Re: Turkey Point Units 3 and 4
Docket Nos. 50-250 and 50-251
Request for Additional Information Regarding
Station Blackout Analysis (TAC Nos. MB8728 and MB8729)

Response to Request for Additional Information Turkey Point Units 3 and 4 Station Blackout Coping Analysis

FIGURE 1. RCS VOIDED VOLUME

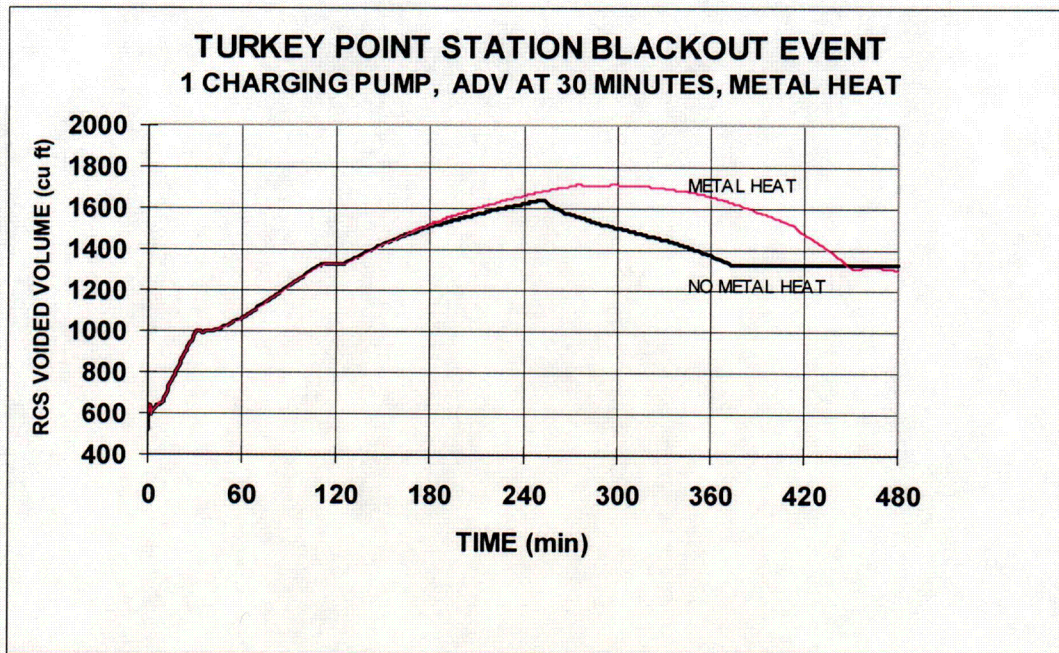
- 1. Perform a hand calculation to take into account metal wall heating effects for the first thirty minutes of the event prior to starting the charging pump. The purpose of the hand calculation is to show that there is no voiding at the U-bends in the steam generators.***

The additional heat load in the vessel upper head results in more voids being formed in that region. As Figure 1 shows, it also takes longer for these voids to start collapsing when metal heat is included. The upper head bubble is not entirely collapsed until around 7.5 hours with metal heat included versus around 6.25 hours without metal heat. However, the bigger upper head bubble generated with metal heat slightly increases the RCS pressure (Figure 2) and the amount of subcooling. Figures 3 and 4 confirm that subcooling is maintained throughout the event and that its magnitude increases when metal heat is included. Figure 5 shows that a substantial amount of liquid mass is always maintained above the top of the hot legs. Similarly, Figure 6 shows the response of the upper vessel liquid level with respect to the top of the hot legs and top of the core.
